SNS-OPM-ATT 2.B-10.a.
Unreviewed Safety Issue (USI) Evaluation Form

Isolate Power Supply Commons in Klystron Gallery PPS Racks and isolate Linac/HEBT Gate Control Power

The associated Permanent Change Request is documented through SNS-RAD-ICS-CR-0011 and Design Change Notice SNS-RAD-ICS-CN-0039.

Figure 3 Existing and Proposed wiring of PLC 'C' Power in KL:CAB03

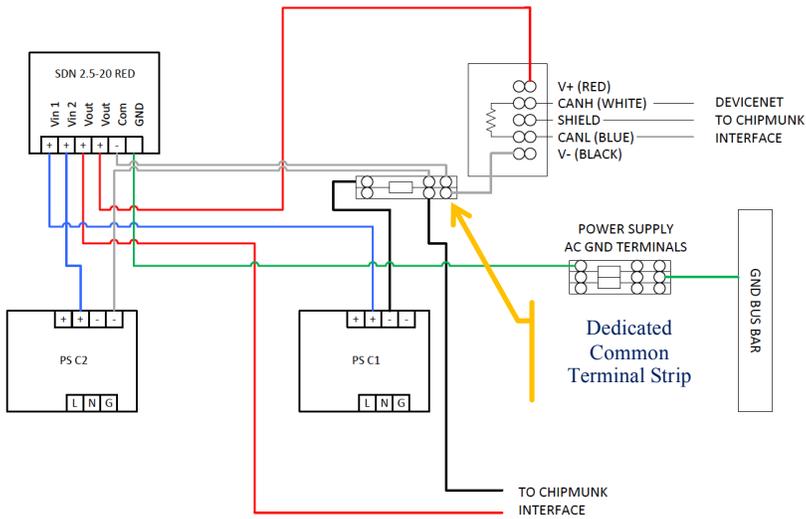
- 1) Remove wires that connect PPS Chipmunk (PLC ‘C’) DC power returns (commons) to earth ground.
- 2) Re-terminate the PLC ‘C’ power supply commons to a dedicated common terminal strip in lieu of using a Device Net connector as a common termination point.
- 3) Re-wire the Linac/HEBT tunnel gate junction boxes to use relays instead of diodes to electrically isolate the two sources of control power for the gate magnetic lock.

Install a bussed terminal strip. Connect each power supply, the redundancy module, and field commons to this terminal strip. Figure 3 shows the existing wiring configuration with power supply commons tied to a Device Net connector as well as the modified power wiring using a dedicated terminal strip. The revised power supply wiring is fully documented through approved revision controlled drawings listed in PCR SNS-RAD-ICS-CR-0011.

Figure 4 Existing gate maglock control using steering diodes

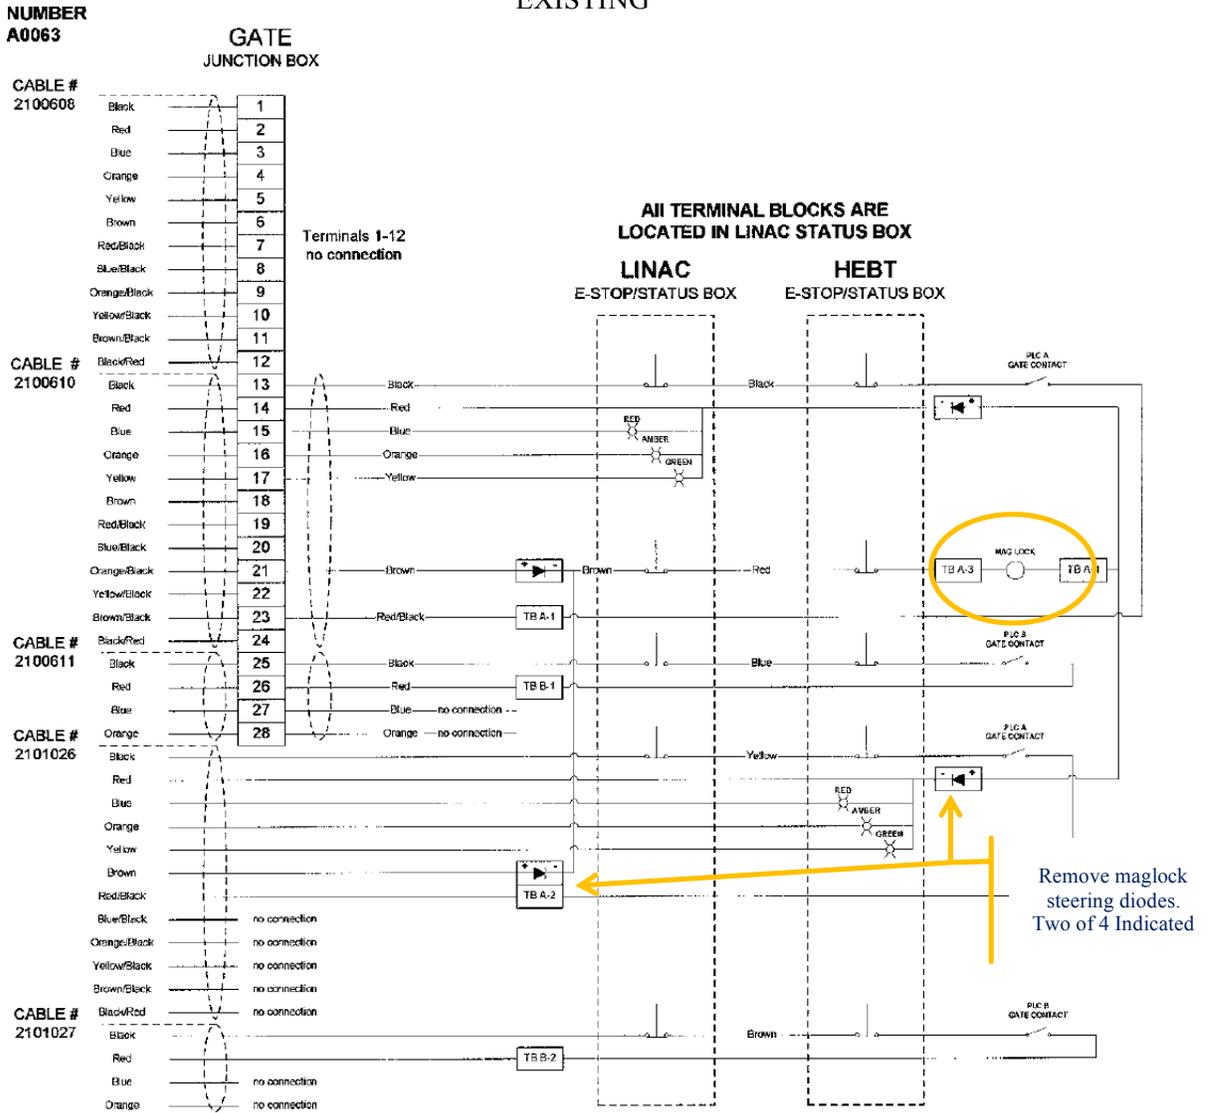
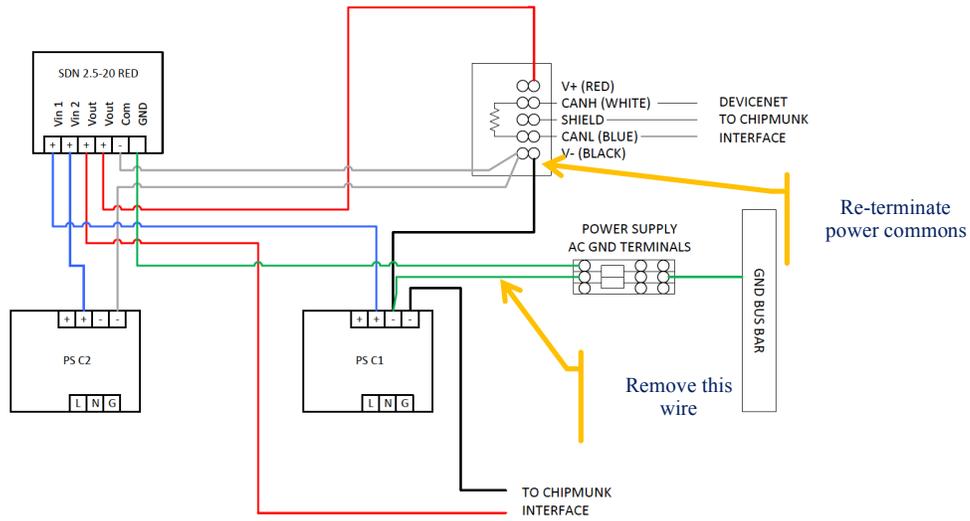
The steering diodes will be removed from the gate interface boxes.

Two relays will be installed to isolate the HEBT maglock control power from the Linac maglock control power. The relays will be located in the PPS junction box immediately above the gate.

The gate control contacts are arranged as a logical 'OR' where either the Linac or the HEBT PPS can lock the gate. Figure 4 shows the existing gate maglock controls with steering diodes. Figure 5 shows the modified gate maglock controls with relays used for isolation between the Linac and HEBT PPS systems.

Note: In the process of updating the gate wiring diagram, details such as wiring terminals were added to the revised drawings as shown in Figure 5.

Figure 6 Linac/HEBT Gate junction box assembly highlighting modifications

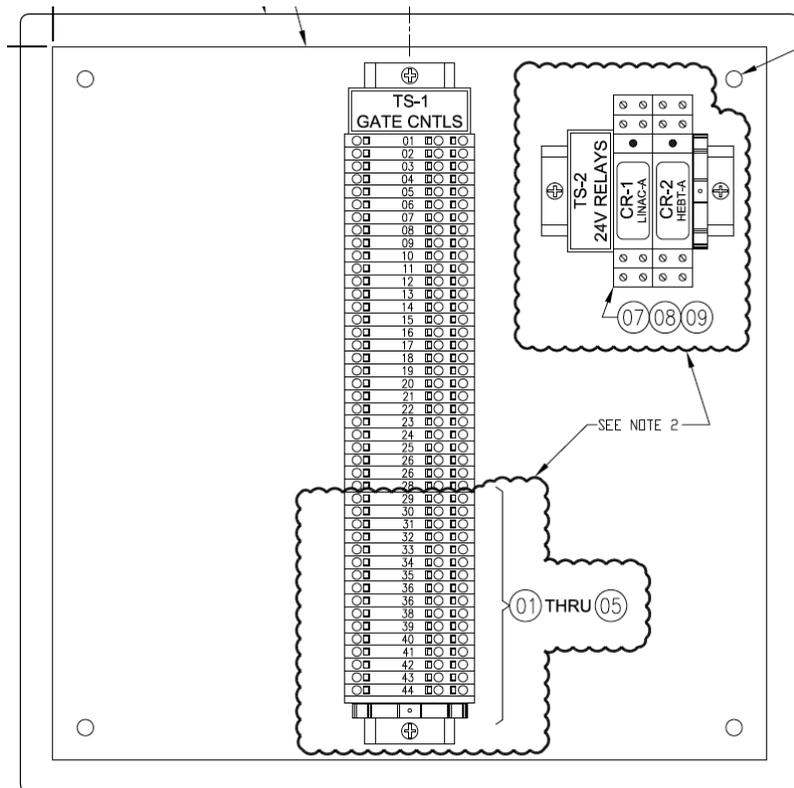
The only hardware fabrication is to install modified Linac (JB101) and HEBT (JB301) gate junction boxes at the Linac/HEBT gate in the accelerator tunnel. The modified junction boxes eliminate the steering diodes. Adding the relays to the PPS gate junction box will be done in-situ. Figure 6 shows the gate junction box with modifications highlighted.
